SERVICE BULLETIN

N° **139-605**

REV. : A - March 9, 2021

ATA 32 - ELECTRICAL WHEEL BRAKE CABLE ASSY REPLACEMENT

Figure 9

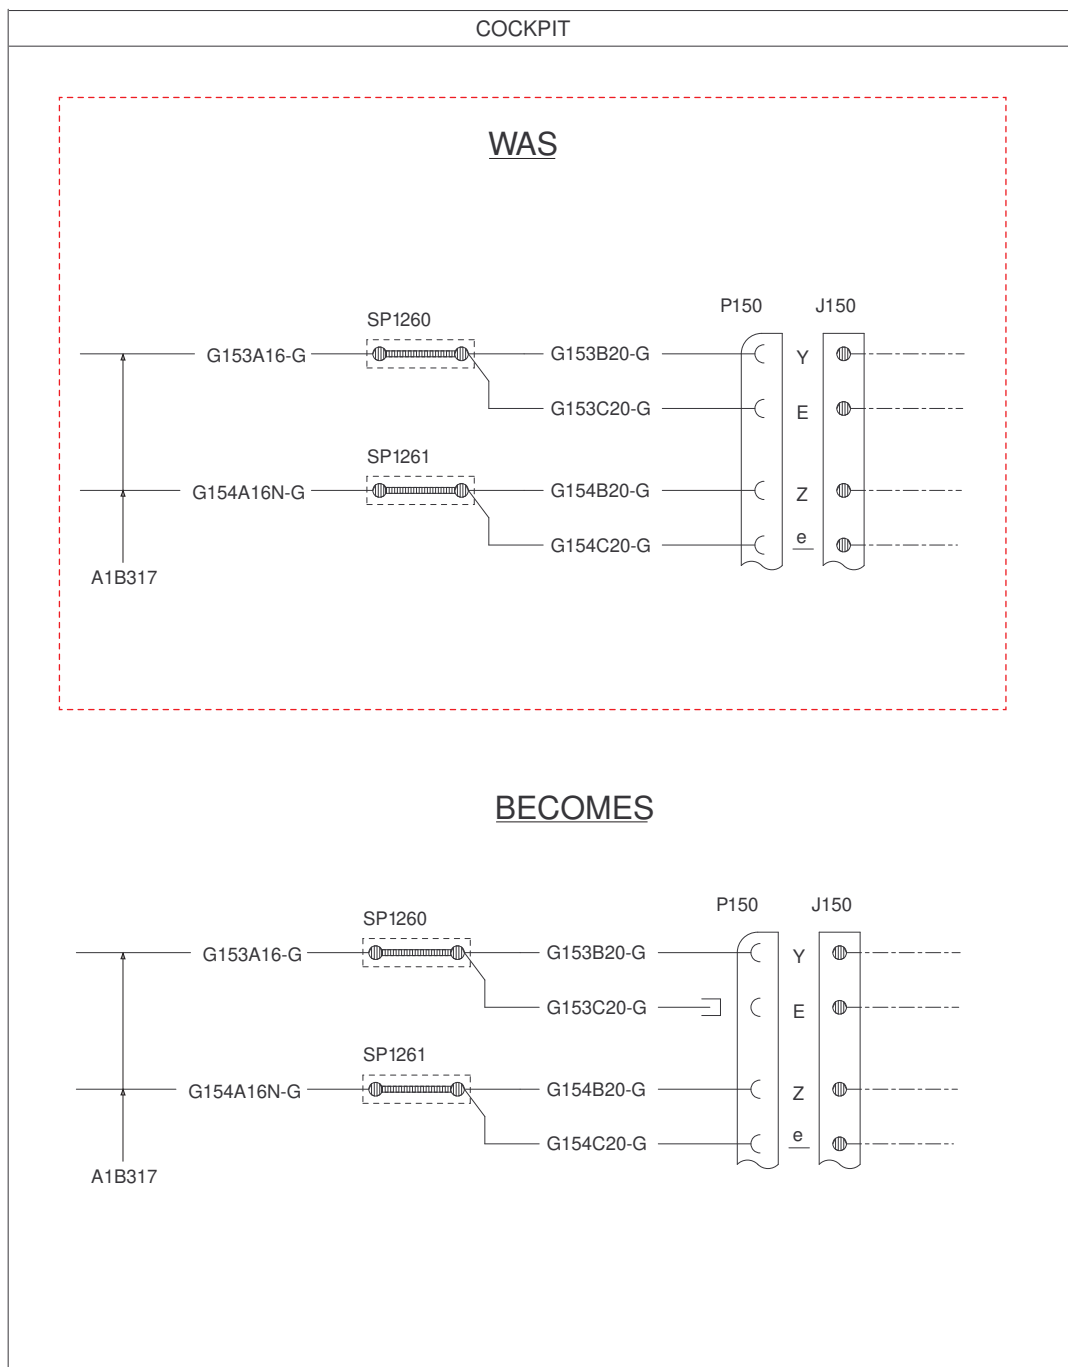
- 5.5 Disconnect connector P150 from connector J150.
- 5.6 With reference to Figure 9 wiring diagram (WAS), using an electrical tester, check if pin E and pin Y of the connector P150 are short-circuited.

- 5.7 If pin E and pin Y of the connector P150 are short-circuited, perform the following procedure otherwise proceed with step 5.8:
 - 5.7.1 With reference to Figure 9 wiring diagram (BECOMES), remove the electrical connection of wire ID G153C20-G (C/A A1B317) from pin E of the connector P150.

- 5.7.2 Stow wire ID G153C20-G using an applicable cap.
- 5.8 Connect connector P150 to connector J150.
6. With reference to Figure 4 (or 6) and to Figure 8 wiring diagram, check the modification made according to the following procedure:
